# Connector Improvements

8 Feb 2023

# Present connector

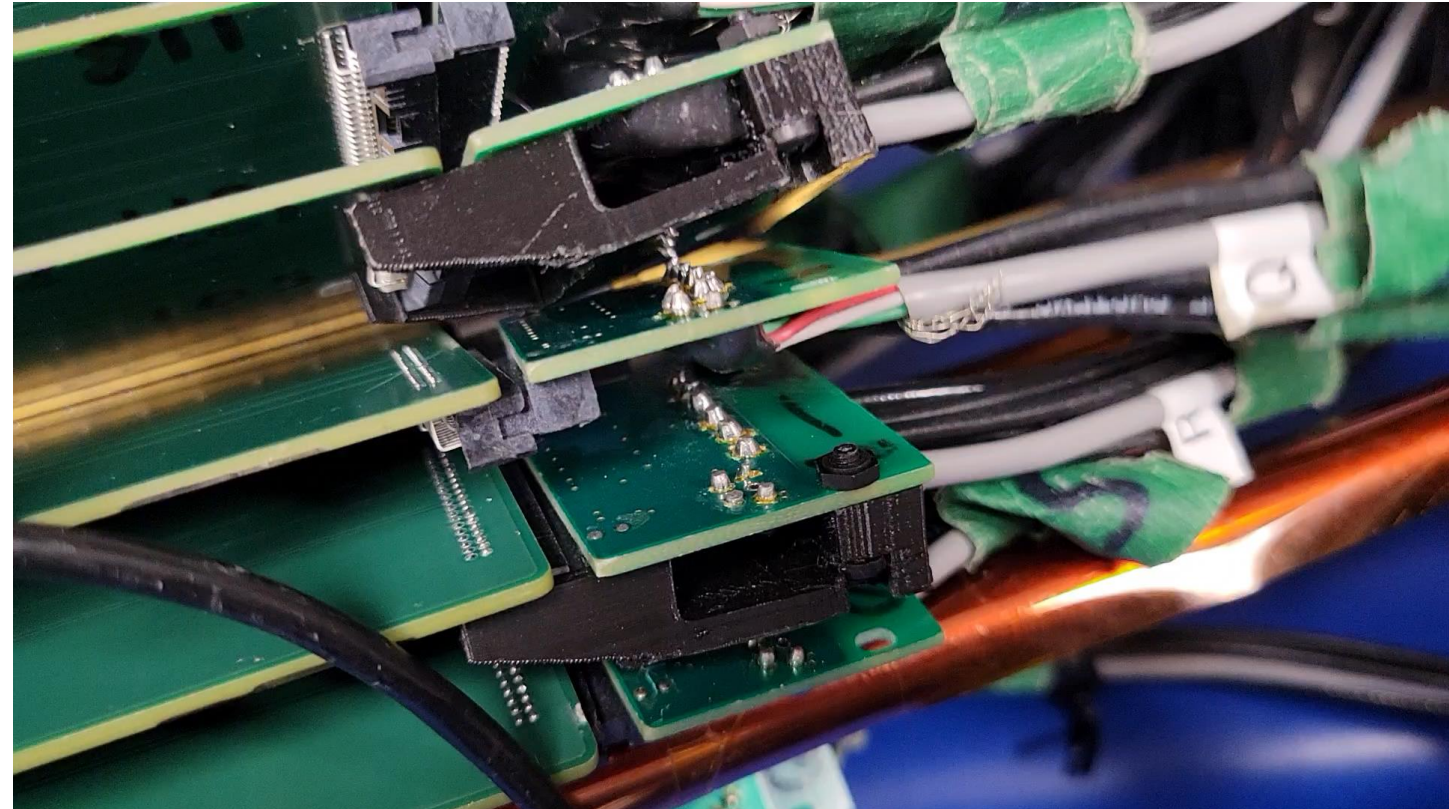
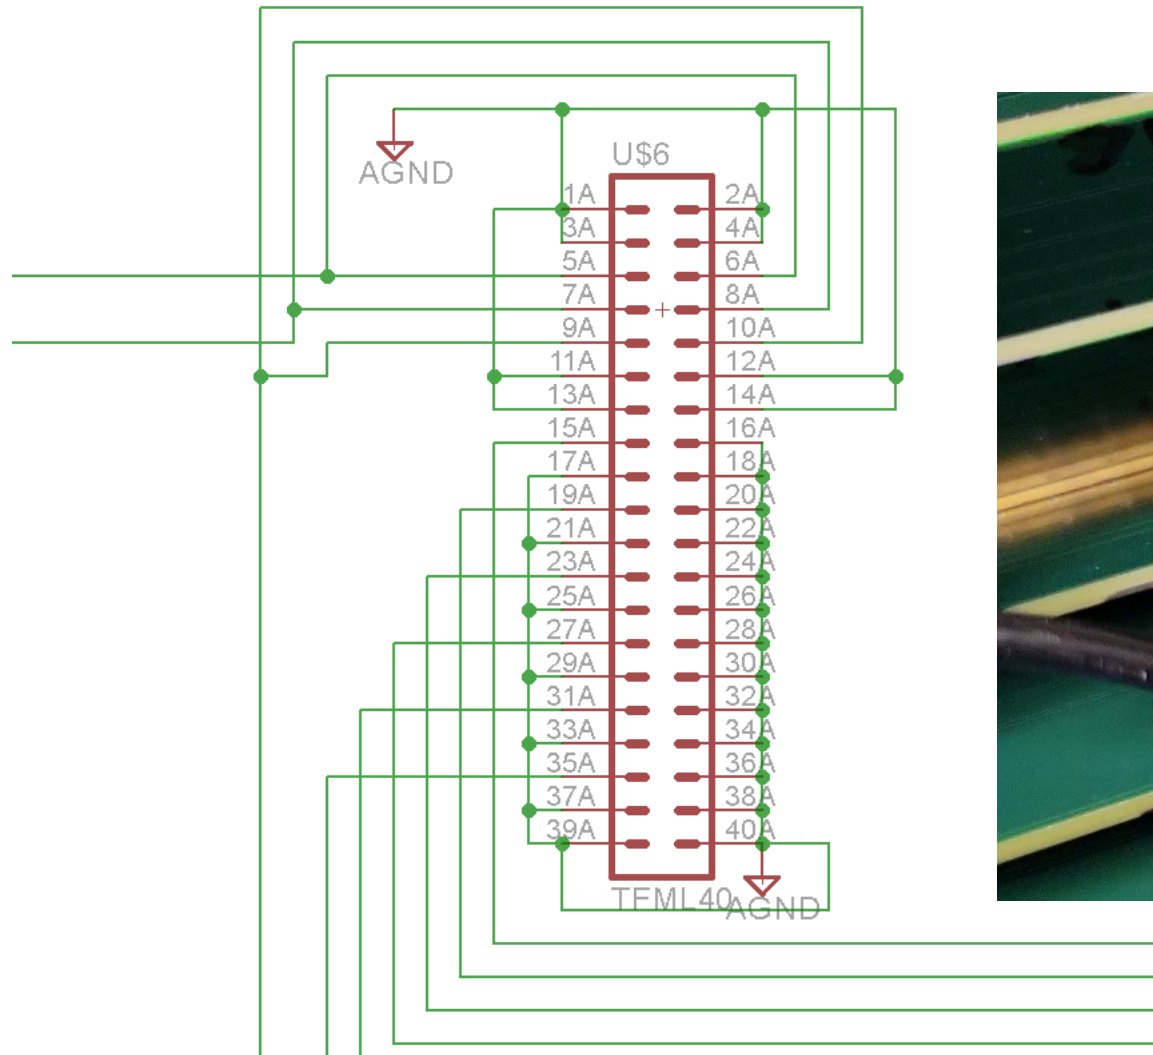
- Connectors have severe retention issues
  - Fall out easily
  - Slight movement causes partial or complete disconnection
  - Hard to put in for installers
- Connector is not appropriate for the signals
- Need to change to a connector or cabling that is more robust

Too small connector, too many grounds, easy to dislodge

- Two approaches have been considered
  - 1<sup>st</sup> would be to use a heavier-duty right-angle header with 0.1" pin spacing
  - This would allow cables to be connected requiring much more force and therefore more retention
  - Also would have better ground
  - 18" pigtail cables would then be connected to these prior to installation making assembly much easier
  - 2<sup>nd</sup> would be to solder pigtail cables directly to each board.
